Public Service
Electric and Gas
Company

FEEDWATER VALVE CLASSIFICATION AND TESTING
HOPE CREEK GENERATING STATION
DOCKET NO. 50-354

ATTACHMENT 1

ATTACHMENT 2

FIGURE 6.2-28
SHEET 2 OF 48

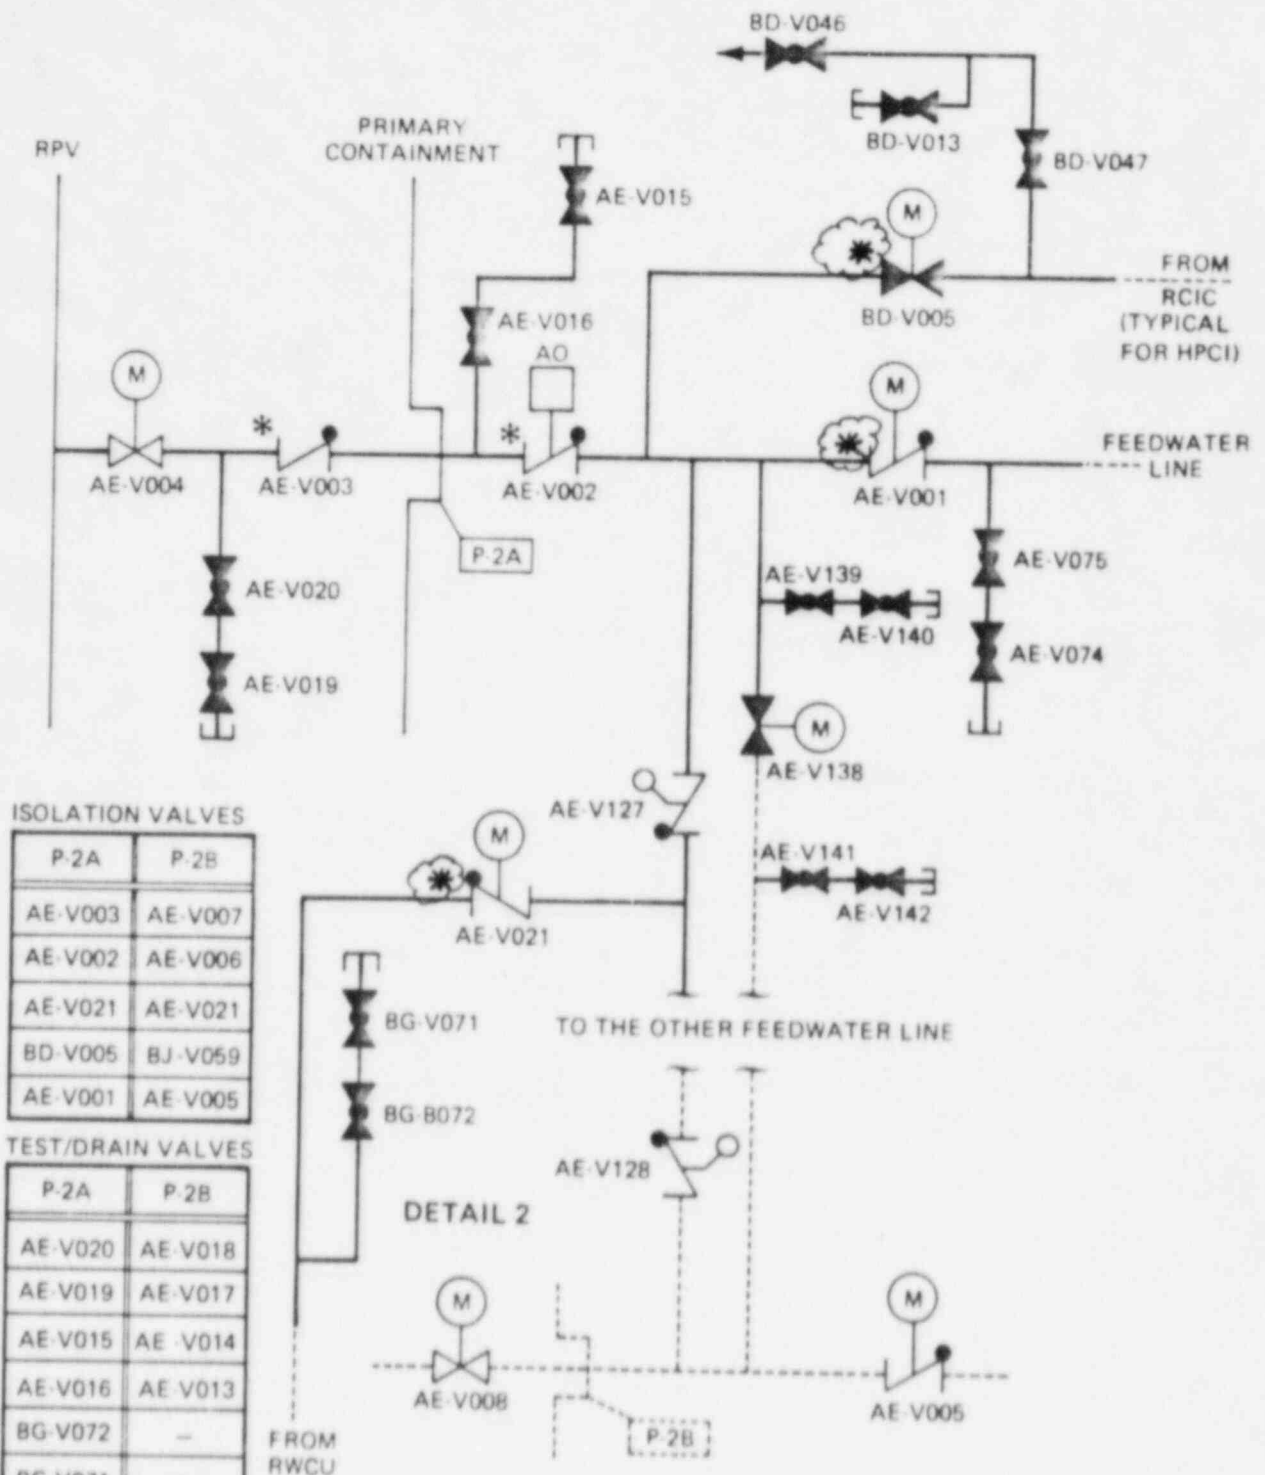
With regard to the first point of discussion, in addition to classifying valves AE-V001 and AE-V005 as containment isolation valves, the first valve in each branch line between the second and third feedwater check valves will also be classified as containment isolation valves. The lines between the second and third check valves are from the RCIC system (BD-V005), the HPCI system (BJ-V059) and the RWCU system (AE-V021). Hence, these valves, as well as those in the feedwater lines, will be included in FSAR Tables 6.2-16 and 24 (see Attachment 1) and Technical Specification Table 3.6.3-1 (see Attachment 2).

P-2A	P-2B
AE-V003	AE-V007
AE-V002	AE-V006
AE-V021	AE-V021
BD-V005	BJ-V059
AE-V001	AE-V005
